**RE: Addendum #8 RFP 19-33 Steelfield Road Landfill Expansion  
Project Design Build Team**

Please accept this as Addendum No. 8 for the above referenced solicitation.

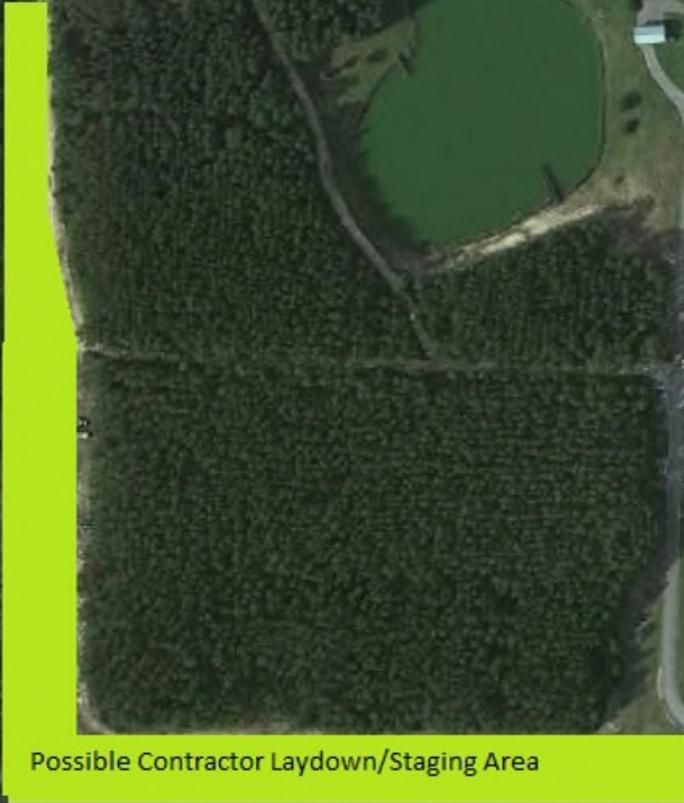
17. I have the proposed contours now, but am still missing the existing contours under the proposed cells 6 and 7. I am unable to digitize them due to the text masking in the plans.

**No additional CAD files are provided. DBTs to work with their AutoCAD professionals to modify the existing files as needed for their use.**

Possible Contractor Laydown/Staging Area

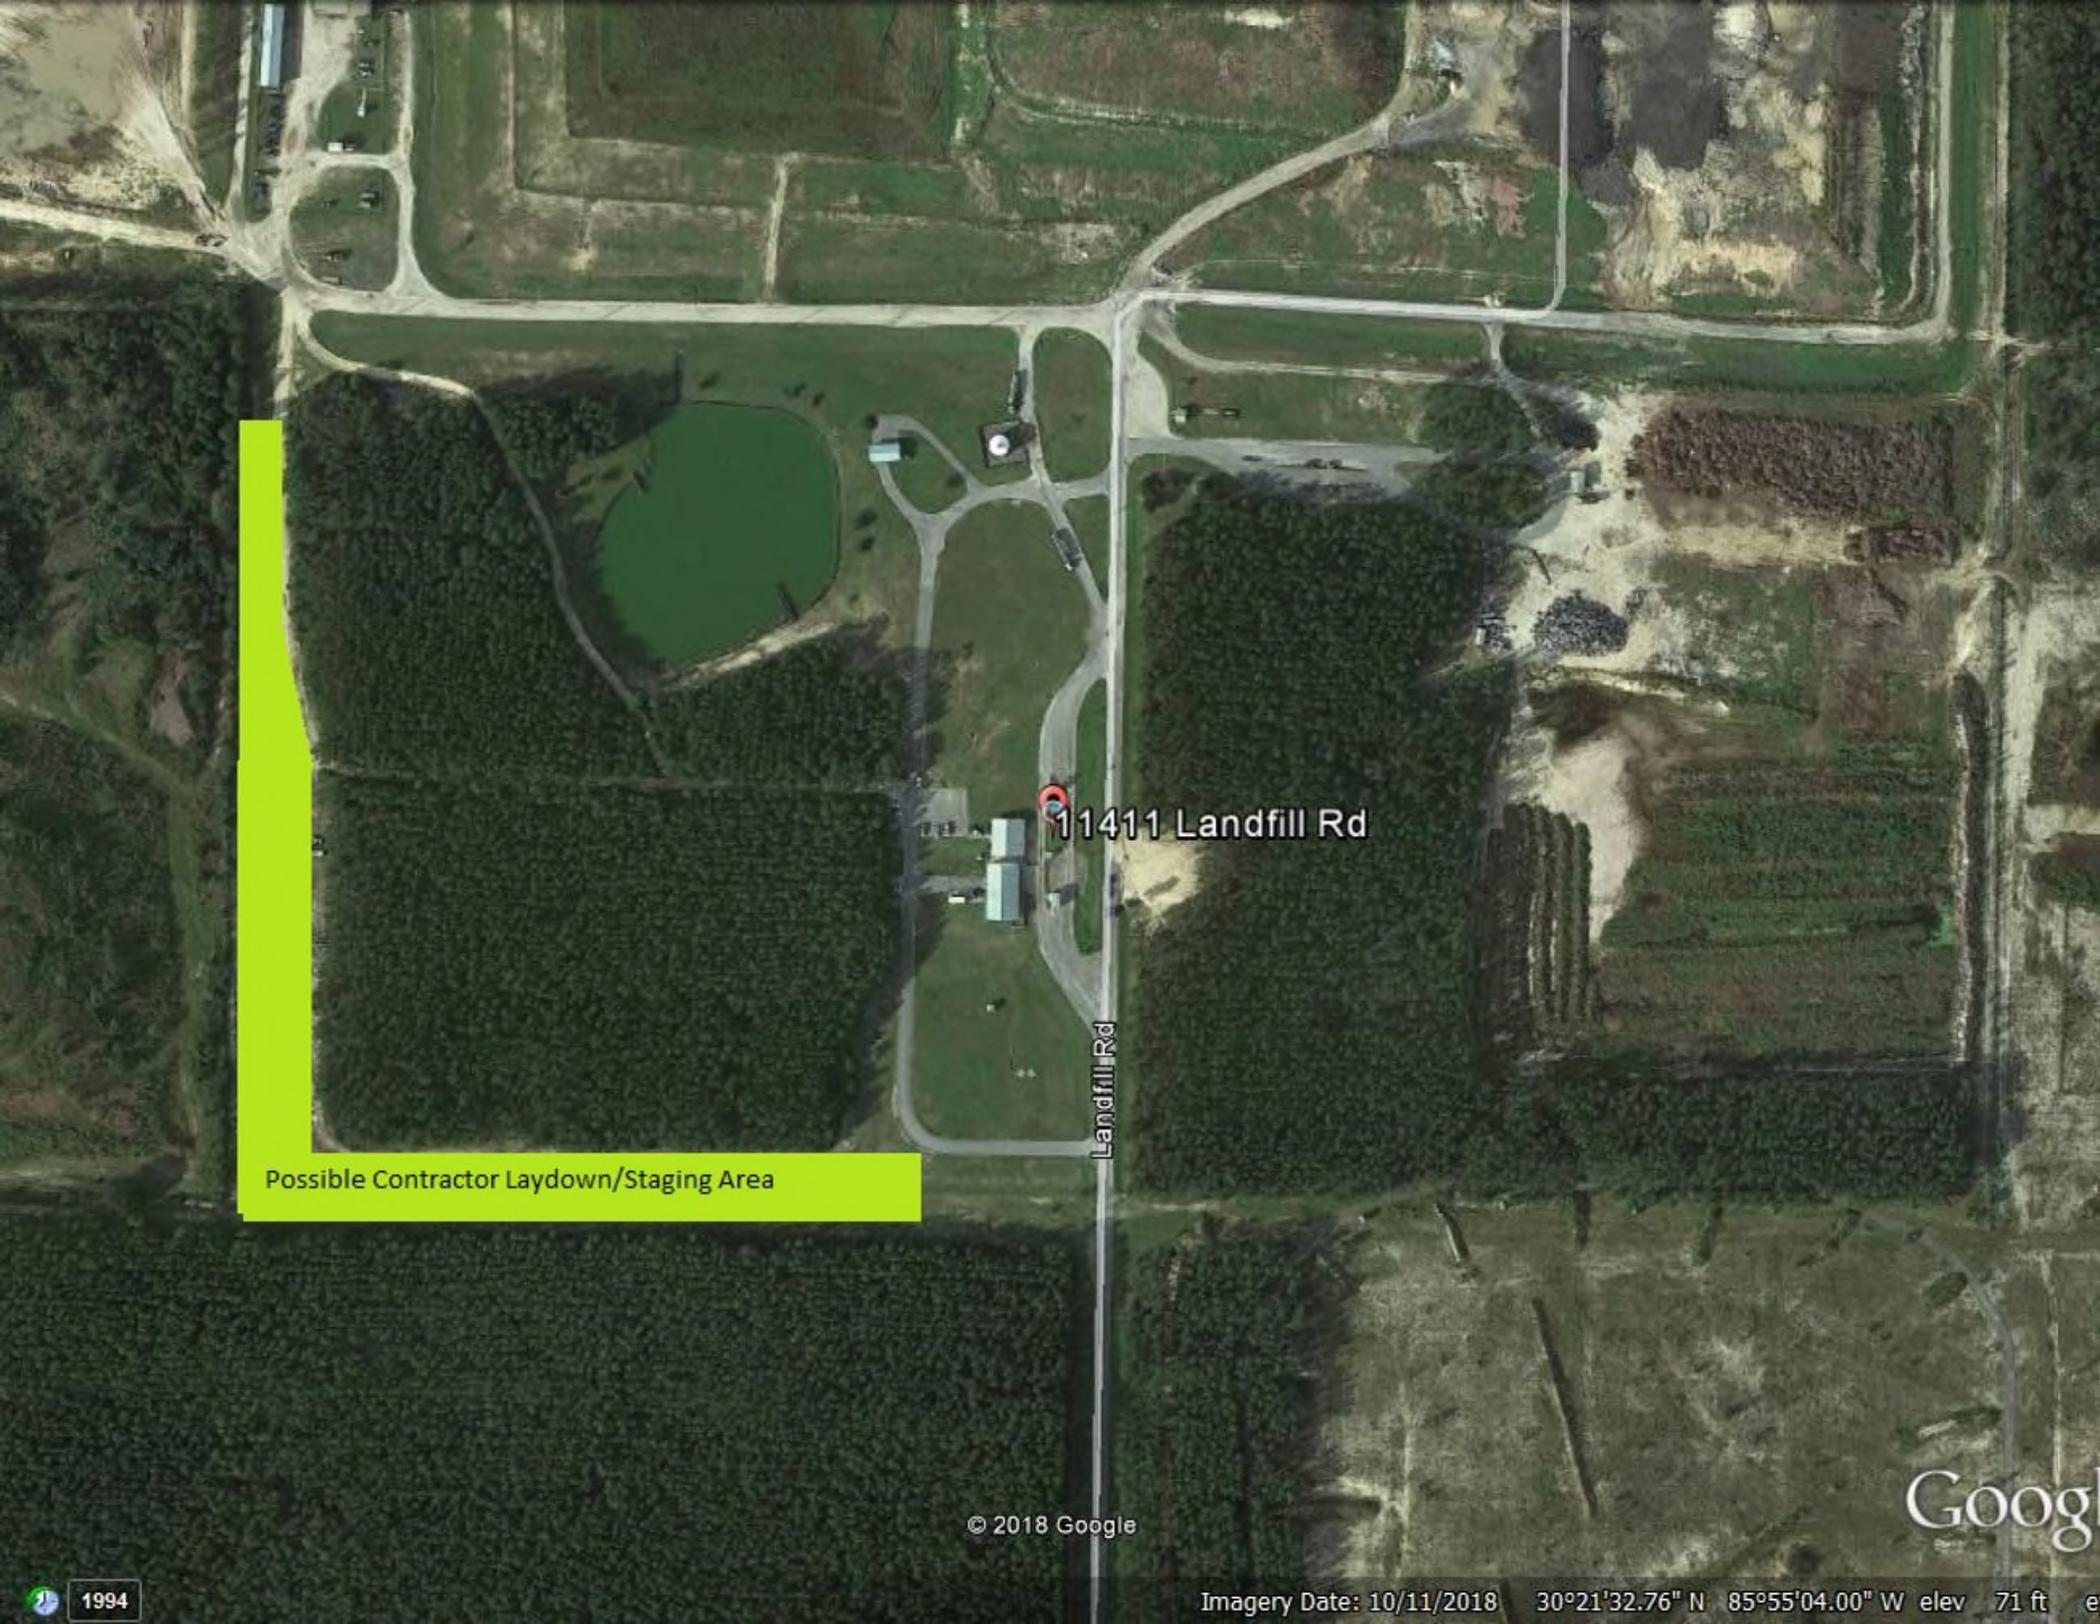
13. Is there an area designated for construction and office laydown?

***Please see attached map***
